**HEB AUSTIN NO 33**

*Pamela Abee-Taulli  
Environmental Program  
Coordinator,  
Development Services  
Department*

**SP-2020-0400D**

# VARIANCE REQUESTS

# VARIANCE REQUEST 3

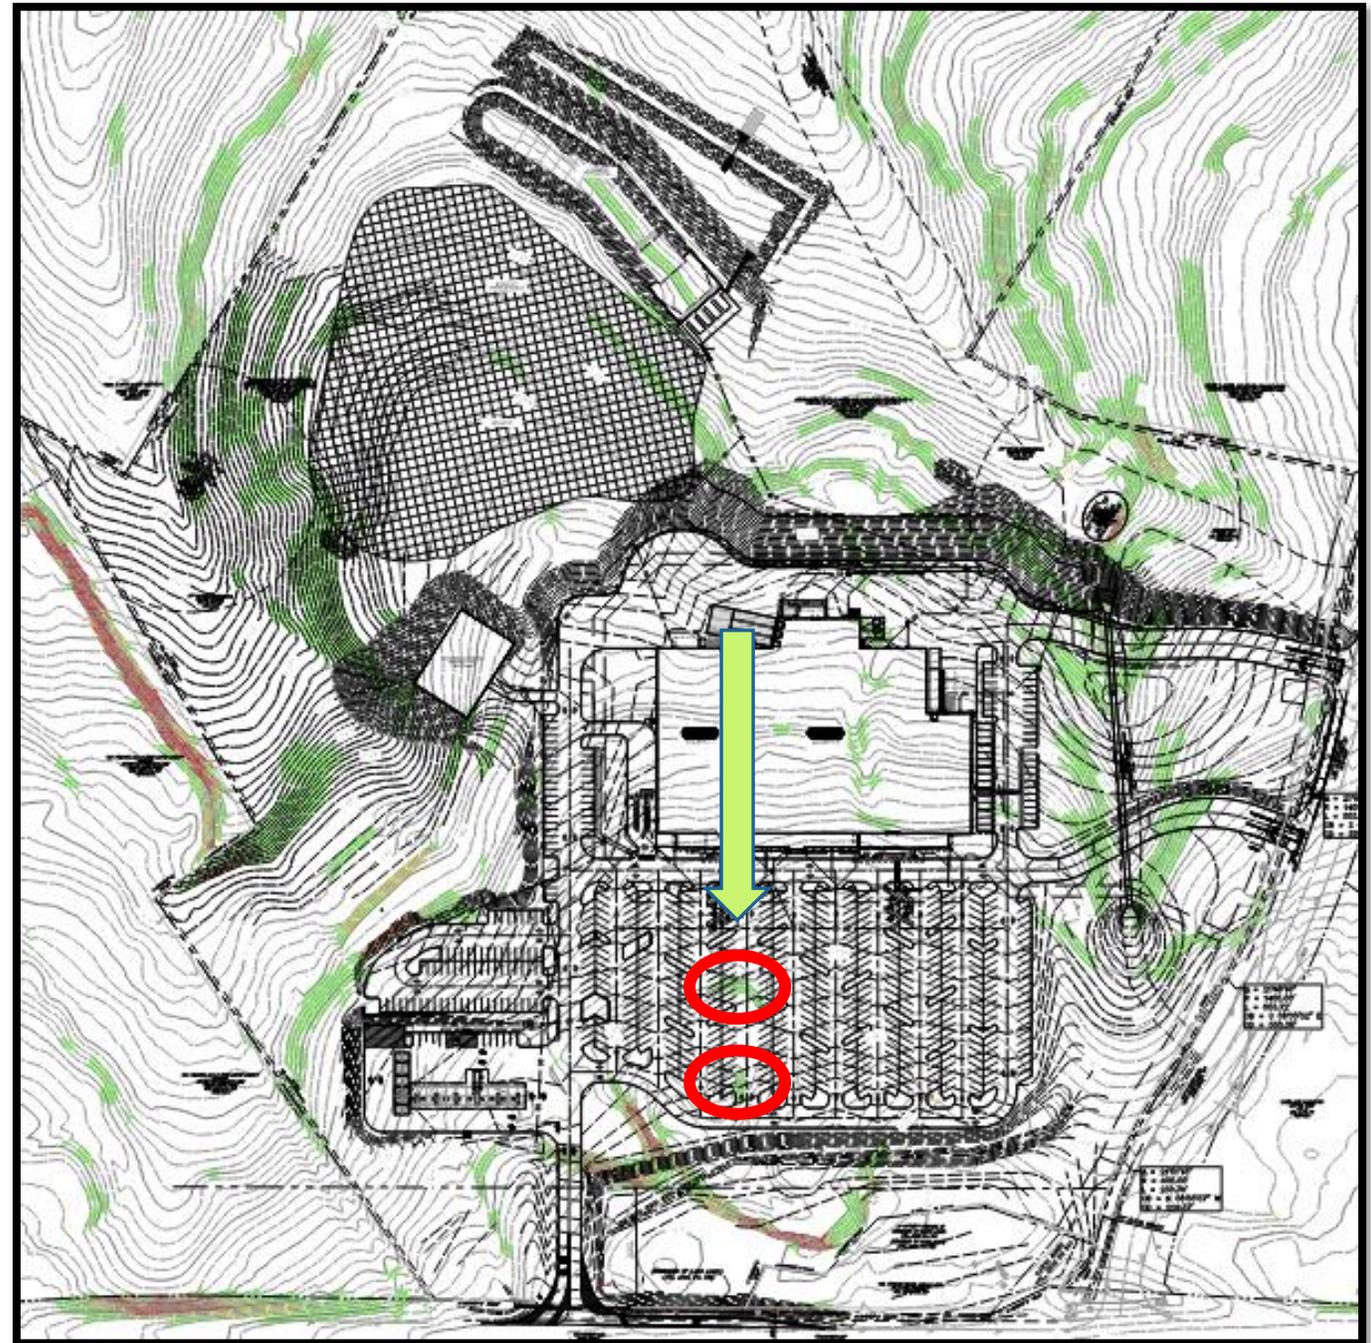
Allow **construction of a parking area** on a slope with a gradient of more than 15 percent.

The parking lot is located and shaped to minimally impact steep slopes. Because of the widely spaced nature of the Hill Country slopes, it is difficult to design a large parking lot that avoids all slopes over 15 percent grade. The parking lot is pulled back from slopes at its periphery. The only slopes over 15 percent are in or near the center of the lot.

# VARIANCE REQUEST 4

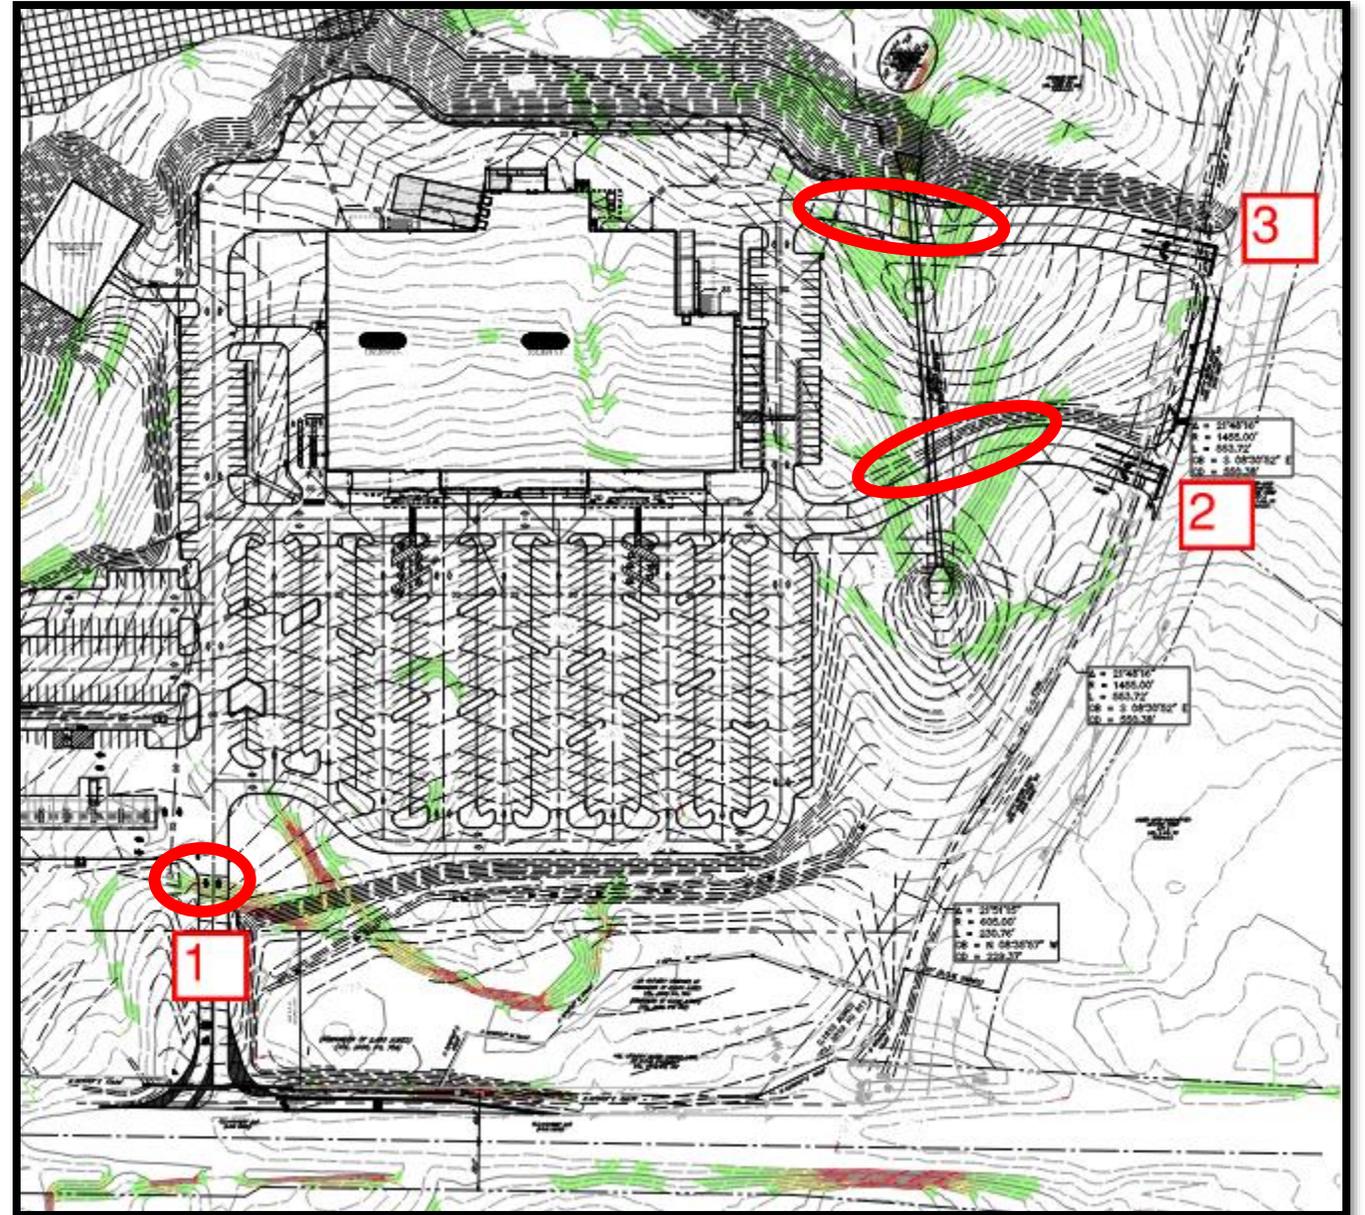
Allow **construction of a driveway** on a slope with a gradient of more than 15 percent.

## Driveways 1 & 2

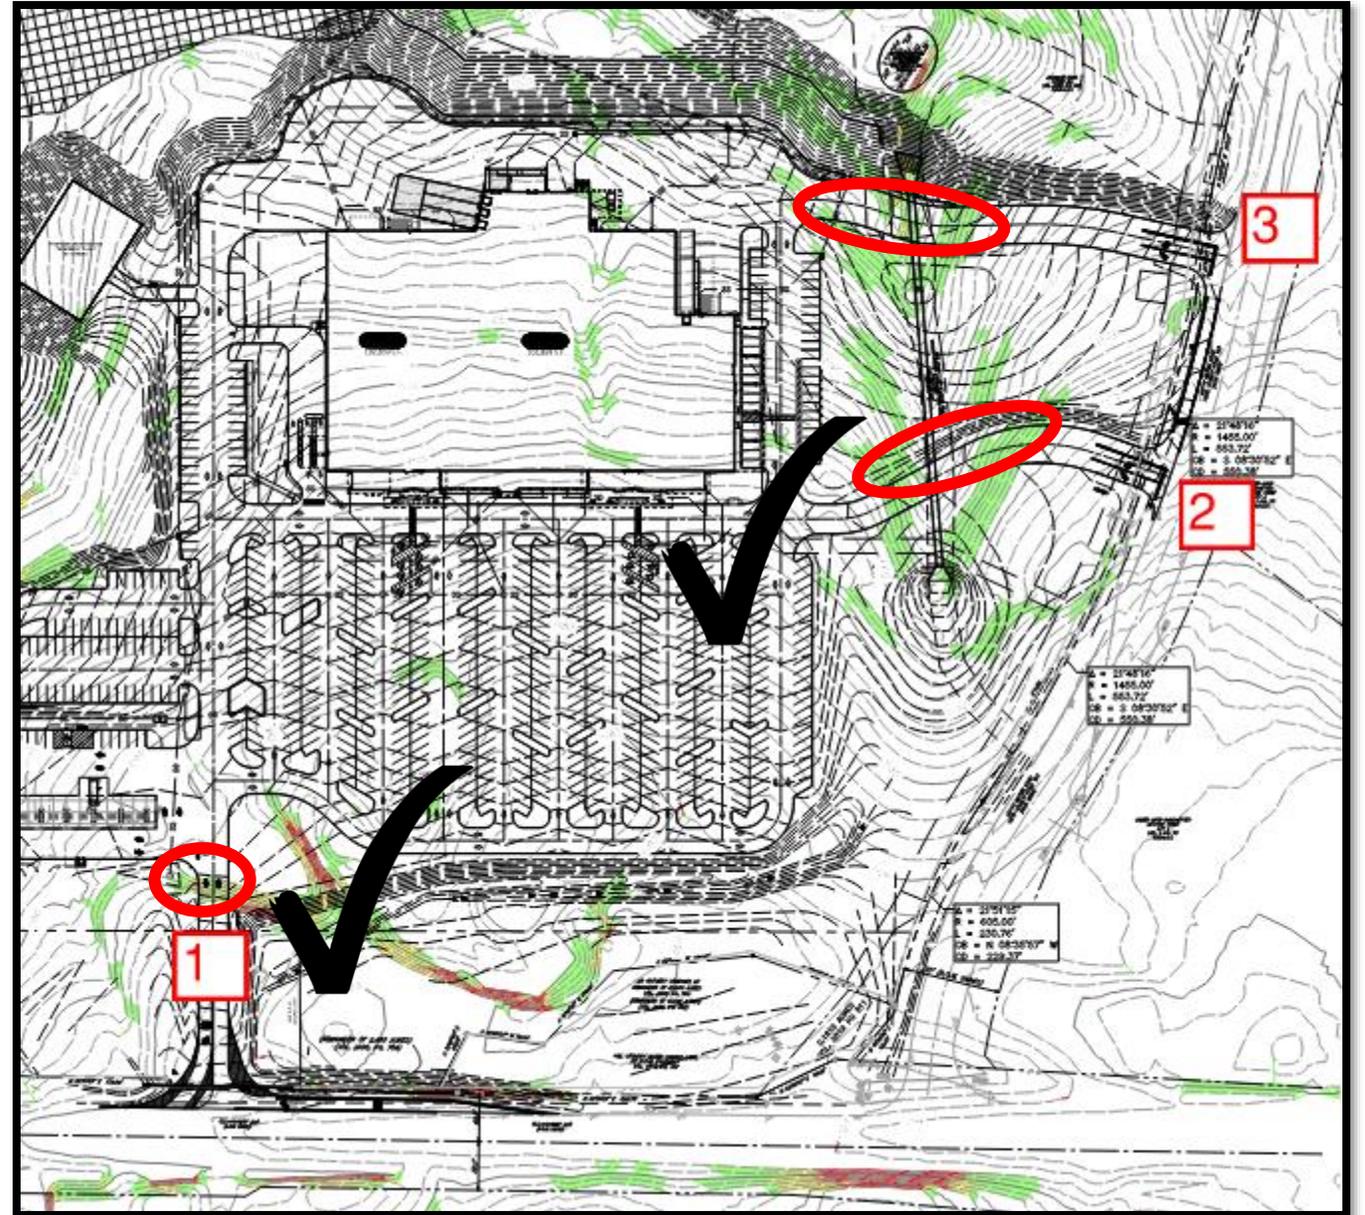
- Necessary primary customer access from the major roadways.
- Code compliant.

## Driveway 3

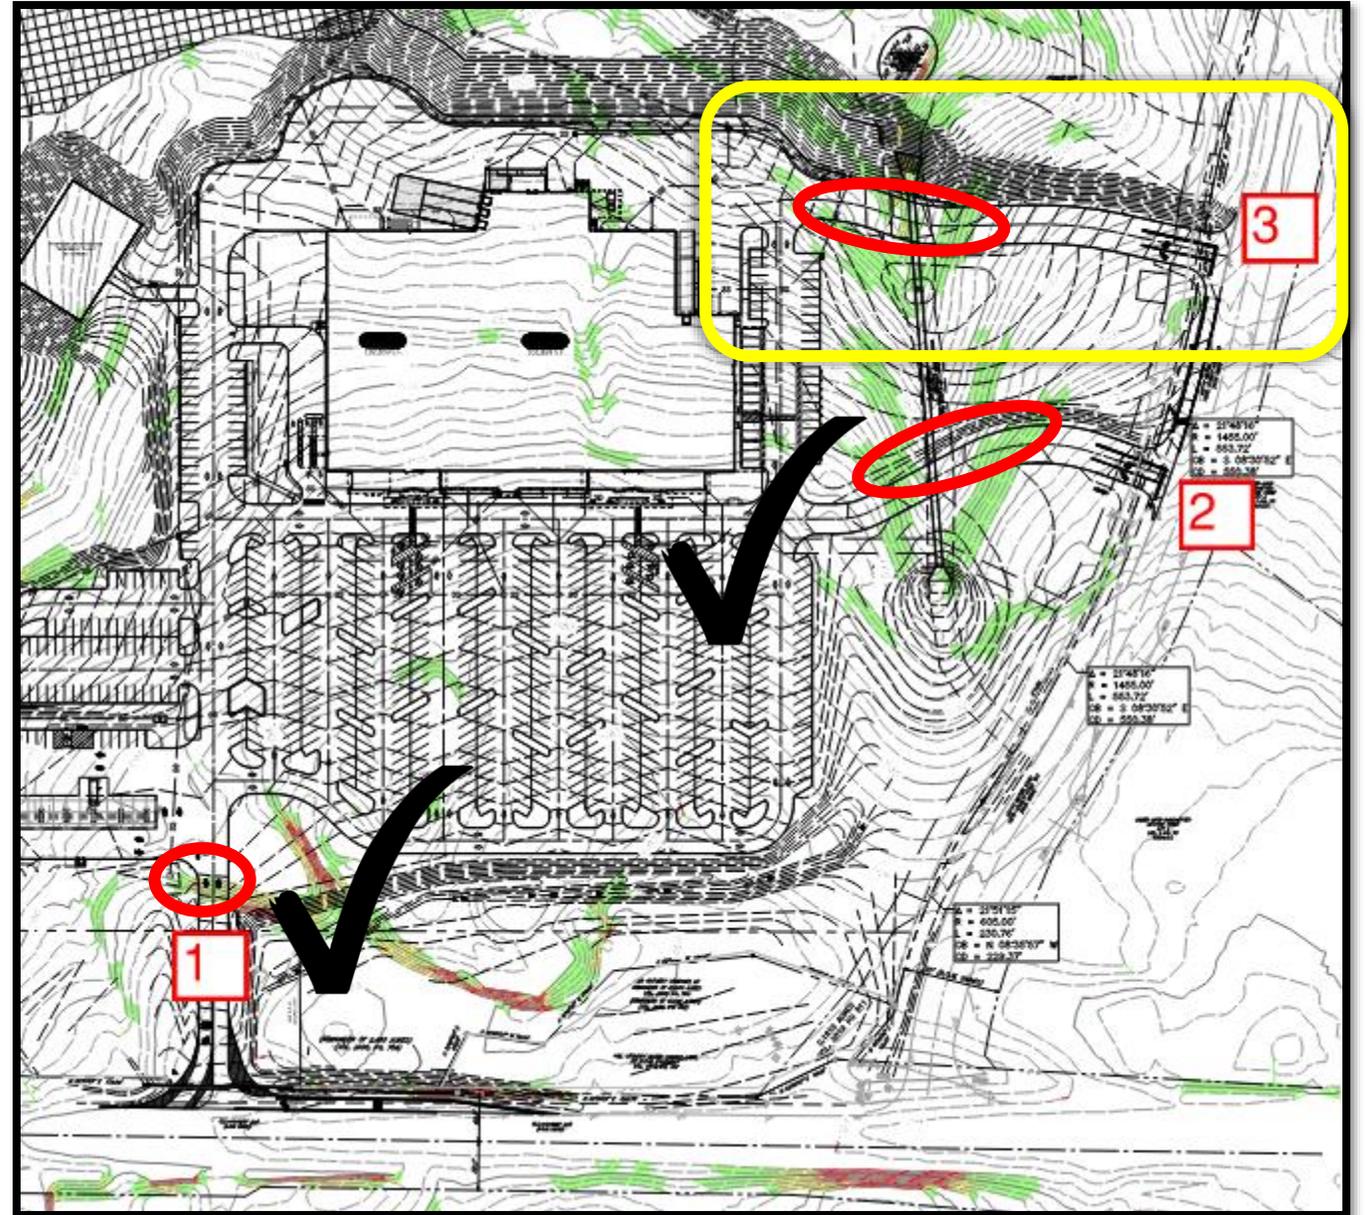
- Truck access for loading dock
- Not “necessary to provide primary access” LDC 25-8-301].

But – satisfies Transportation Criteria Manual guideline that freight loading facilities should be designed and located to minimize intermixing of truck traffic with other vehicular and pedestrian traffic on site. [TCM 9.3.0, #2]
